**CITY OF DELAND
REGULAR MEETING OF THE
HISTORIC PRESERVATION BOARD
MAY 1, 2025 AT 5:00 PM
CITY HALL, COMMISSION CHAMBERS
120 SOUTH FLORIDA AVENUE
AGENDA**

1. **Historic Preservation Review (Alteration) of a commercial building at 118 North Woodland Boulevard**
Application No.: HPB25-063
Applicant: Fredrick Peace
Owner: Woodland, LLC

2. **Historic Preservation Review (Demolition) of a residential accessory structure at 403 East Rich Avenue**
Application No.: HPB25-050
Applicant/Owner: Jacqueline & Mark Barden

RE: **Certificate of Appropriateness (Exterior Alteration) for a commercial building at 118 North Woodland Boulevard**
Application No.: HPB25-063
Applicant: Frederick Peace
Owner: Woodland, LLC
Florida Master Site File: 8VO1657

Top view of the canopy

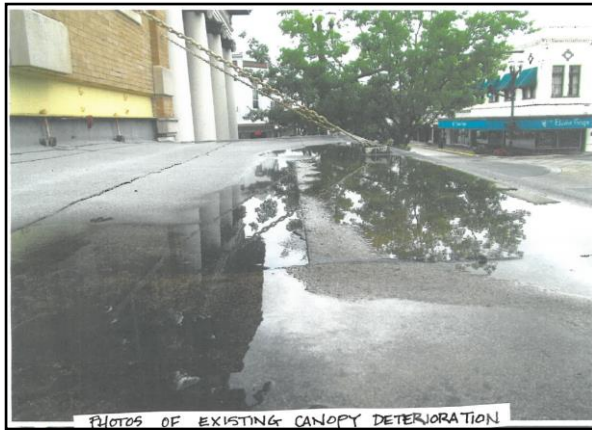
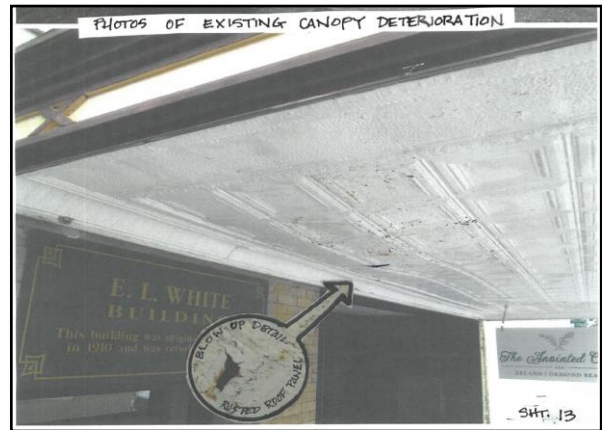
The applicant has provided photographs which show the extent of the deterioration of the awning, however, a structural analysis by an engineer supporting the request for the demolition is not currently available. The options available for this request are to repair the existing structure or to replace it with an acceptable replacement structure. The building official provided the following assessment after a review of the canopy:

This wooden canopy has deflected over the years to the point that the roof membrane is allowed to pond a significant amount of water. Three chains hold the heavy wooden canopy in place. These chains are connected to the façade of the building. The condition of the mechanical components that are anchored to the top of the structure which hold these chains is unknown, thus the structural integrity of the canopy is unknown. I would suggest that the whole structure be removed and either rebuilt OR install a different structure acceptable to the HPB.

Replacement of the canopy – The awning proposed to replace the canopy is an acceptable replacement for the structure. It is similar to others that exist on facades within the downtown and provides protection for the retail use inside the building.

EXISTING FASCIADE CONDITIONS AFTER DEMOLITION OF THE FORMER CANTILEVERED ROOF WHICH PROJECTED OVER SIDEWALK.

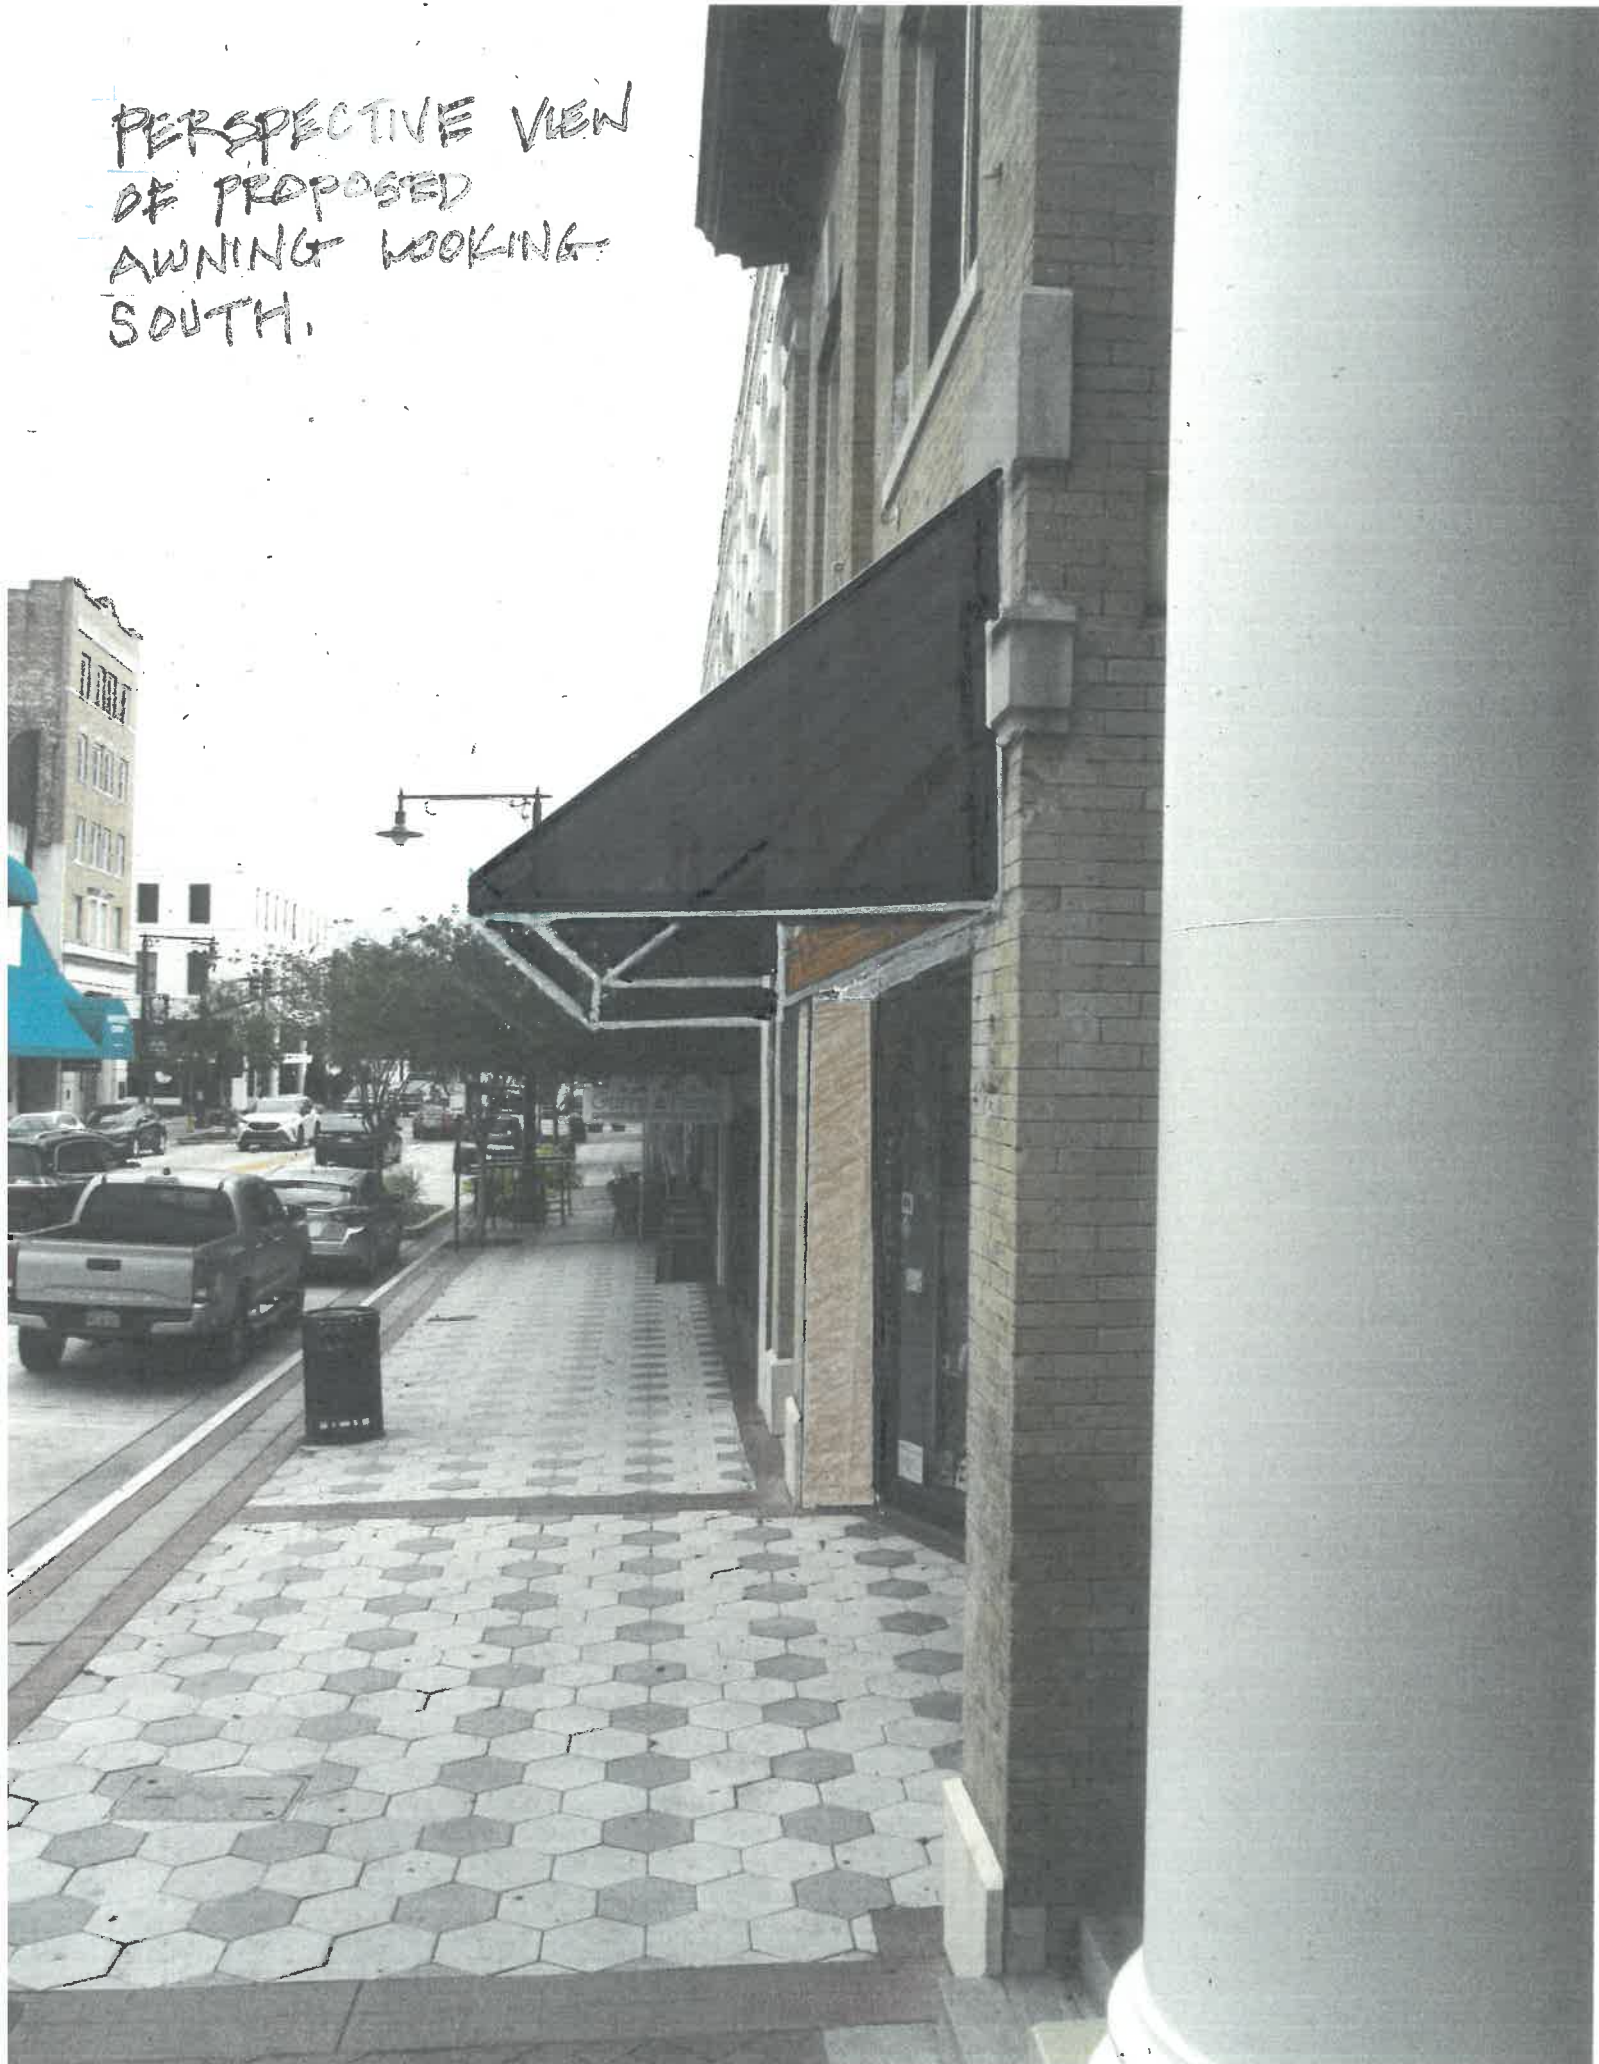
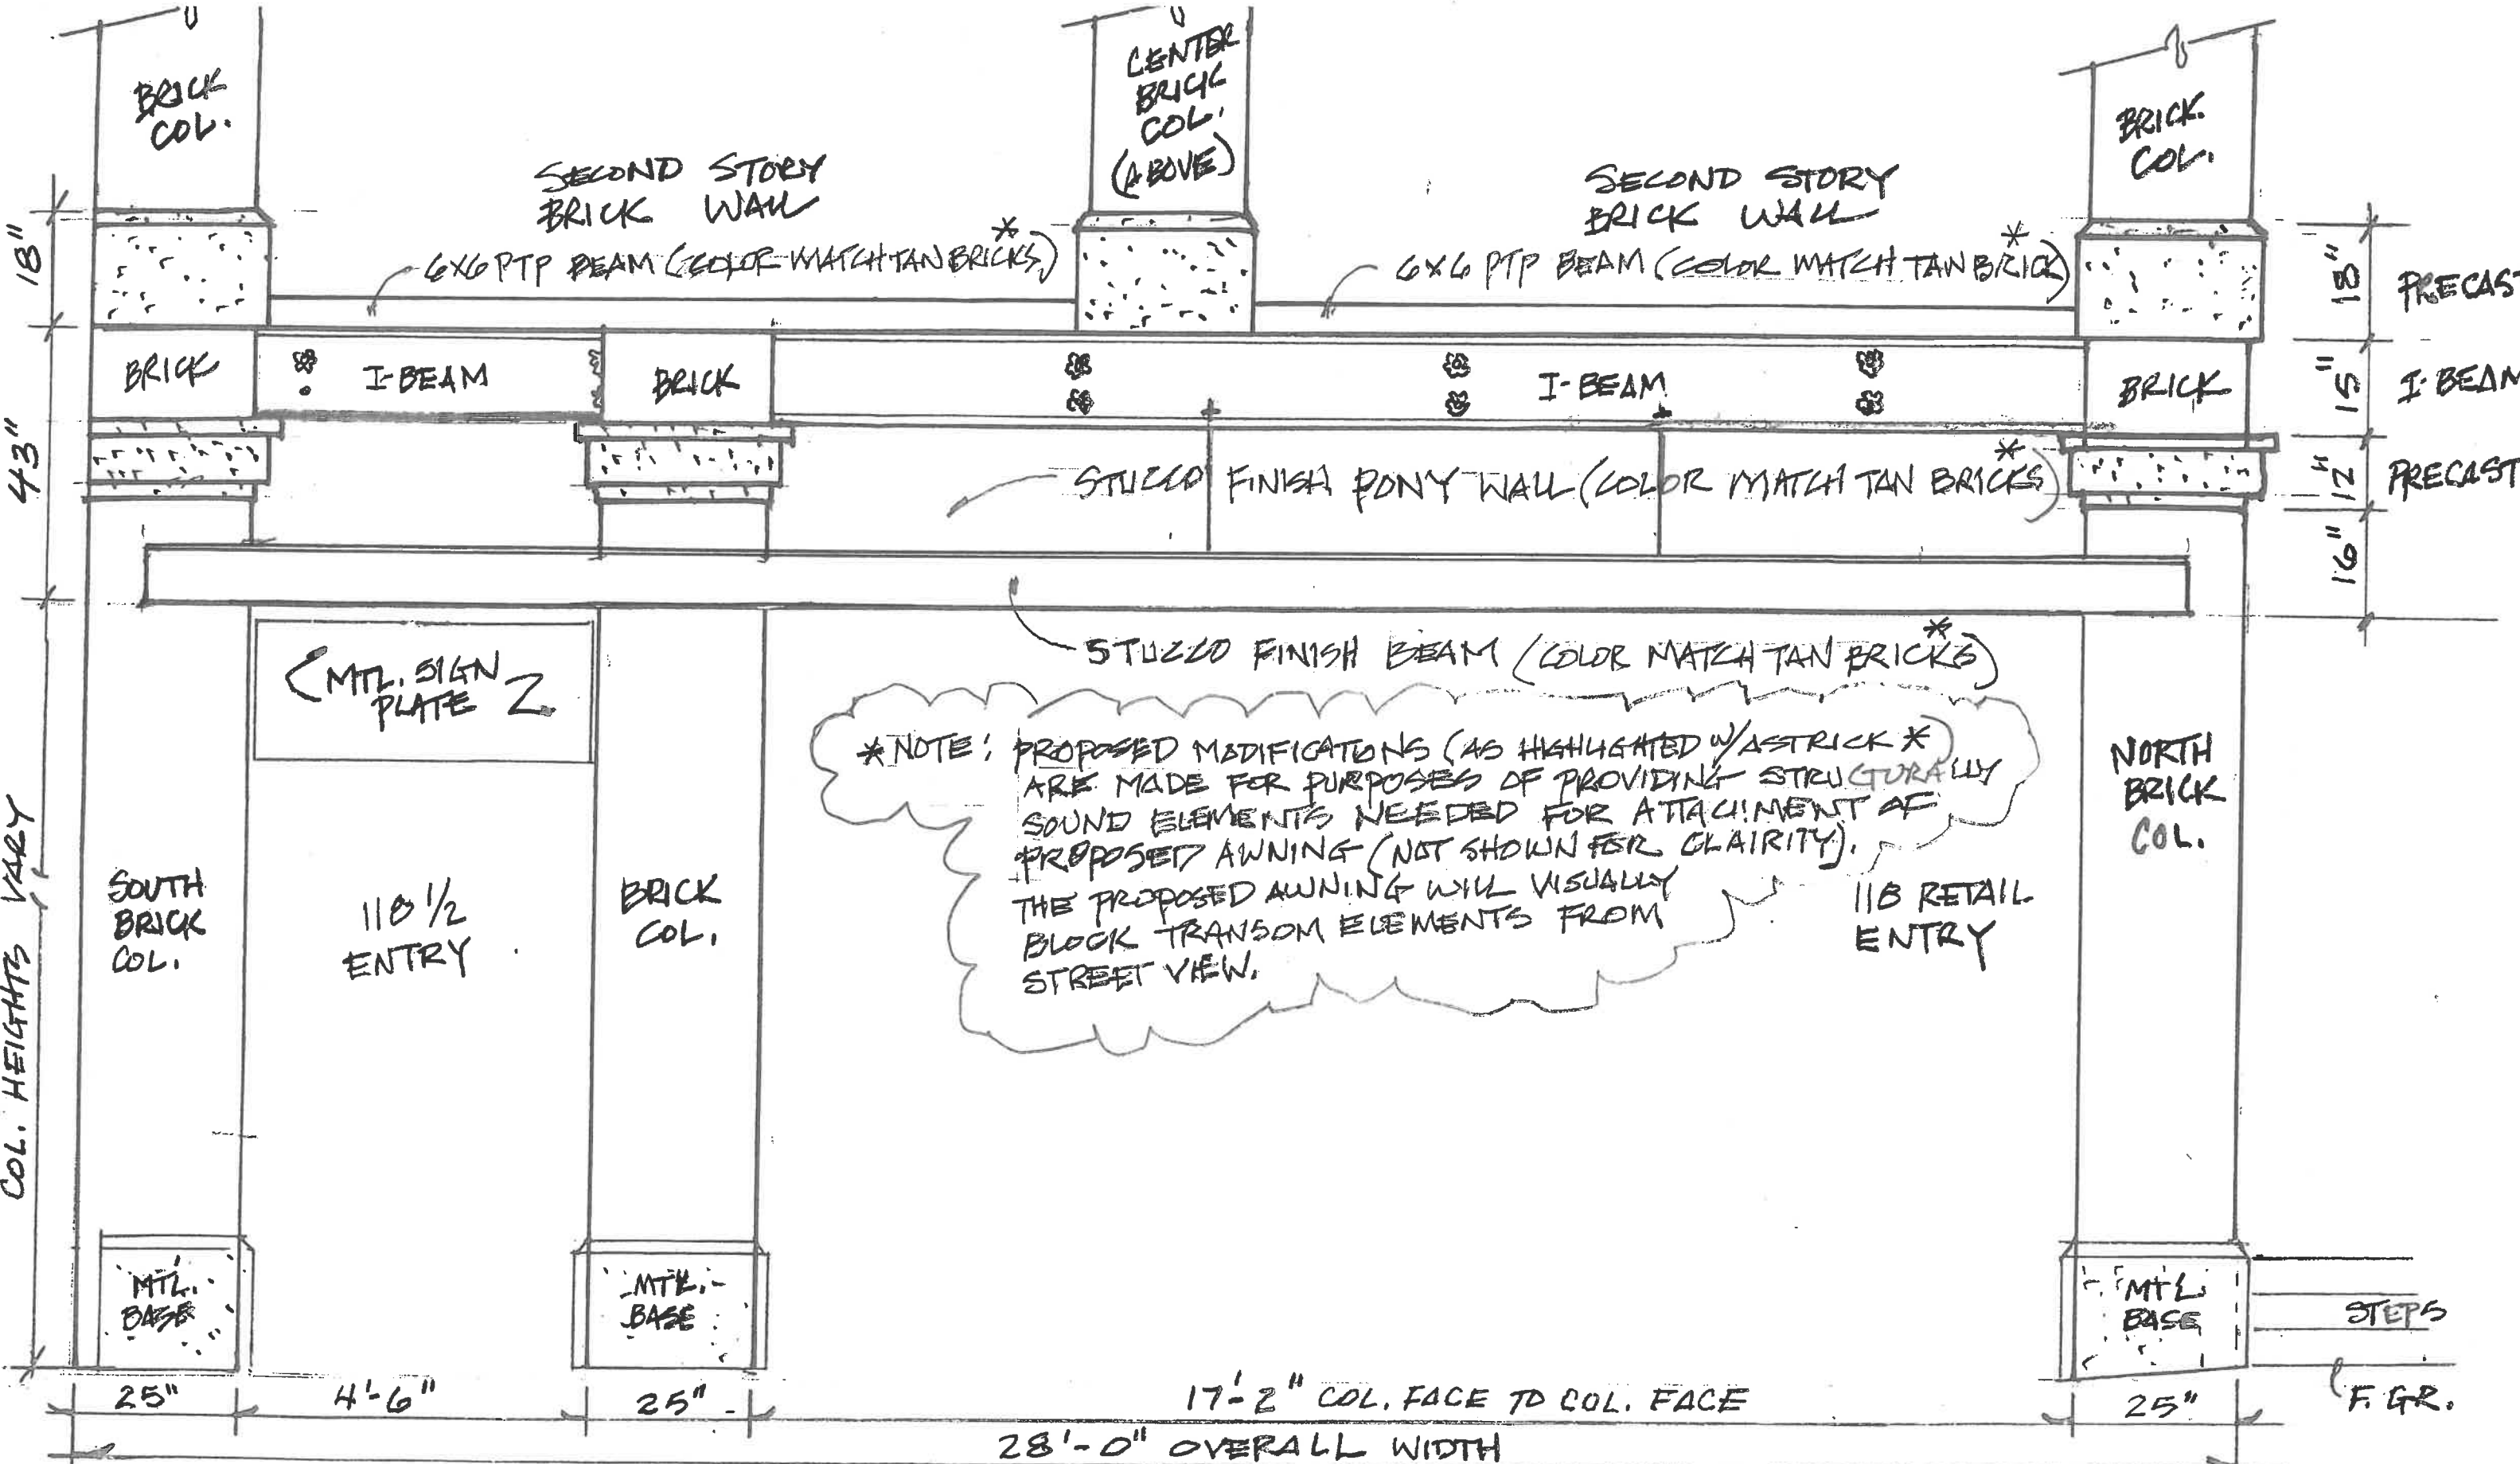
The proposed addition of white stucco over the existing sandstone brick could exacerbate the deterioration, whereas the use of a material that allows the sandstone brick to breathe could further extend the life of the brick. The proposed alteration includes the addition of a stucco modification to structurally allow the installation of the new awning, which is similar to other buildings in the downtown historic district, such as 145 North Woodland Boulevard (Figures 6-8). The applicant should explore other options for securing attaching the awning to the building.

(SCHEMATIC) BLDG. ELEVATION (PARTIAL) SCALE: 1/2" = 1'-0" NORTH
 118 N. WOODLAND BLVD DELAND, FL.

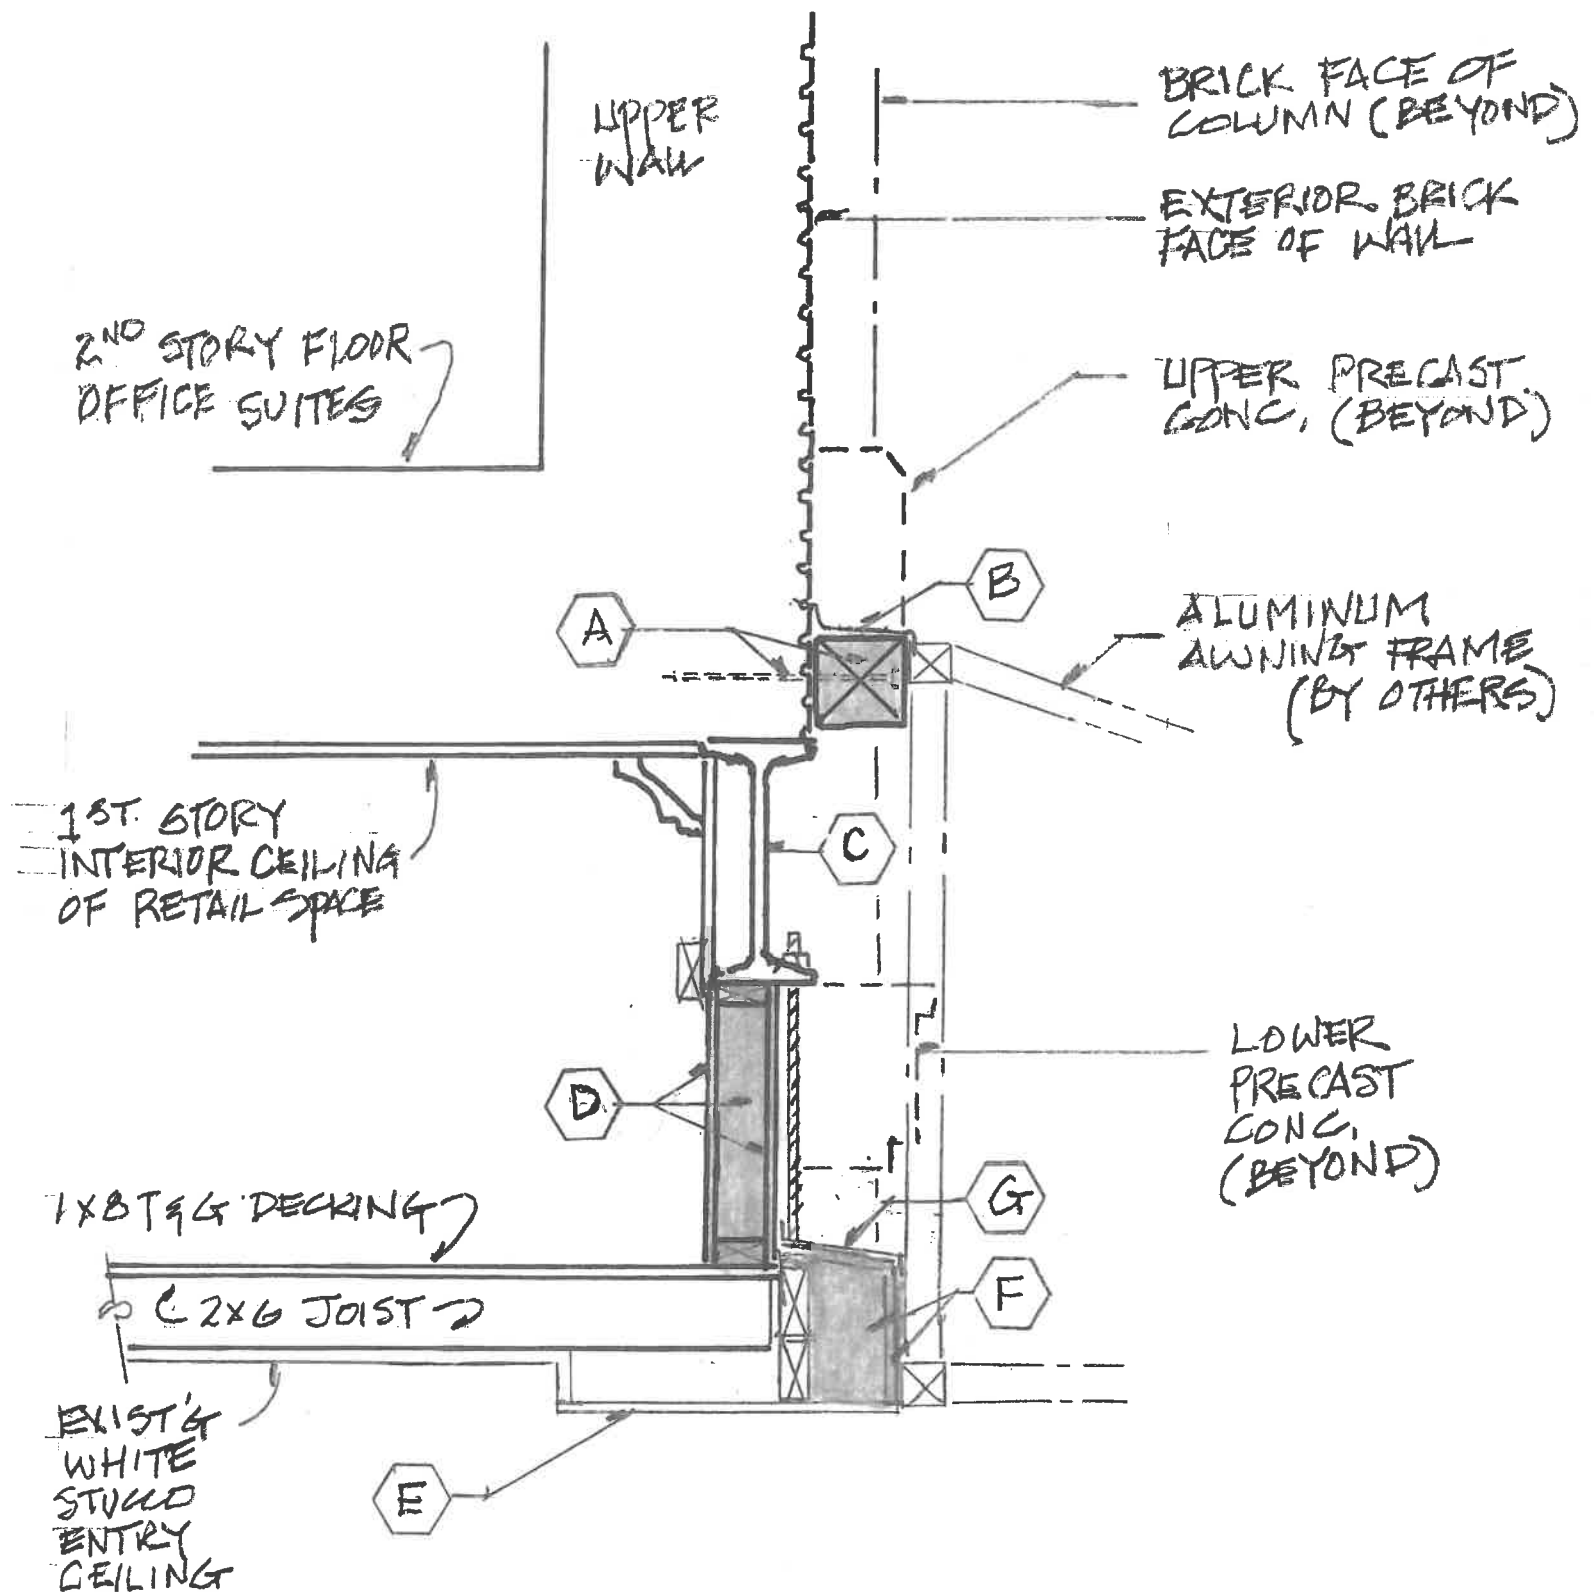
The applicant is proposing to frame in a former display case, on the north brick wing wall, and on the opposite side of the wall, frame in a blind nonfunctioning window, but recess it, resulting in change in the repetition of the relationship of solids and voids in the architectural design, thereby eliminating a portion of the distinctive features and finishes of the building.

The applicant is proposing to add a stucco finish over some portions of the existing first-floor sandstone brick and keeping the first-floor columns and upper-floor sandstone brick unaltered. Although some buildings in the downtown historic district have a stucco finish on the first-floor with brick exterior on the upper floors (Figures 2-5), the new materials should match the existing
